VESTEL	Info tecnica	
	Info tecnica	
Oggetto :	Parti di ricambio : sostituzione modulo alimentazione Power Board da mod. 17PW15 a mod. 17PW20	
		Data : 28.11.2007

SUBJECT : Spare Parts : Changing Power Board from 17PW15 to 17PW20

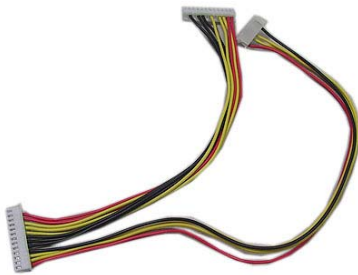
1. Nella sostituzione del modulo d'alimentazione 17PW15-9 con il modulo 17PW20 non viene effettuata nessuna modifica in quanto i due moduli sono perfettamente compatibili.

I cavi di connessione utilizzati su ambedue i moduli sono i medesimi sia in 17PW20 che in 17PW15-9

Art.-nr° 30053985 CNAS13+12+7P/300-200W/DC UL1007AWG24RoHS (cavo collegamento)

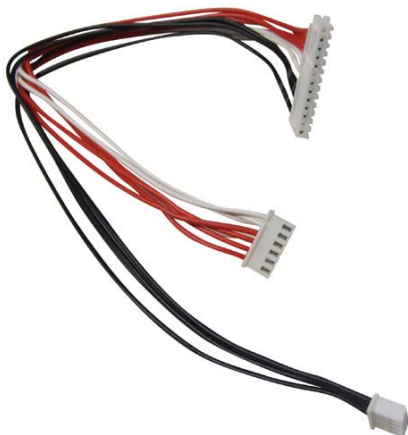
2. . Nella sostituzione del modulo d'alimentazione **17PW15-8 e versioni precedenti** con il modulo 17PW20 devono essere sostituiti i cavi di connessione sotto elencati.
